# **Technical product information**

Topic	High pitched whistle from the engine - Warning light within the DIP - Engine not running smoothly - Numerous DTC's
Market area	Bentley: worldwide (2WBE)
Brand	Bentley
Transaction No.	2059379/3
Level	EH
Status	Released for publishing
Release date	02-Nov-2022

High pitched whistle from the engine - Warning light within the DIP - Engine not running smoothly - Numerous DTC's

Transaction No.: 2059379/3

Figure 2

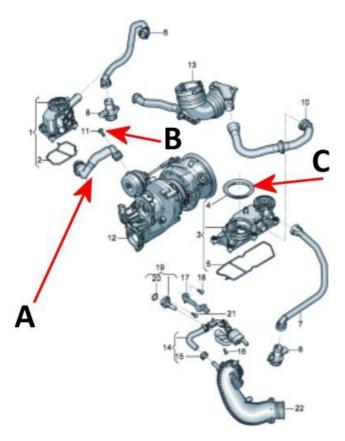
- 1) At engine idle speed Listen for air leaks/whistle noise from right hand side of engine
- Attempt to clear all related DTC's
- Conduct an ignition cycle
- Recheck for the presence of any related DTC's/symptoms NOTE: In the event of related DTC's and symptoms returning carry out the remaining instructions
- 2) Referring to Figure 2 Replace the Bank 1 breather line (Point A) and fixing (Point B) Refer to applicable sections from Rep. Gr 10 Oil mist separator bank 1 To remove and fit
- Replace the oil filler pipe seal to the Bank 2 oil separator (Point C)

Figure 3

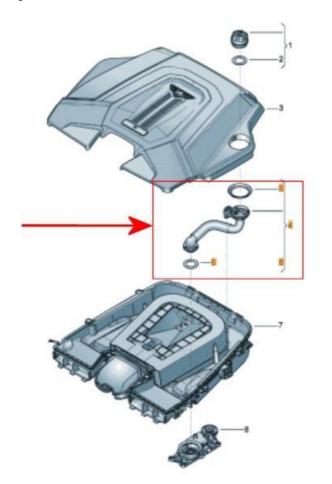
Replace the oil filler pipe including all seals (Figure 3) – Refer to applicable sections from Rep.Gr 10 - Oil mist separator bank 2 - To remove and fit
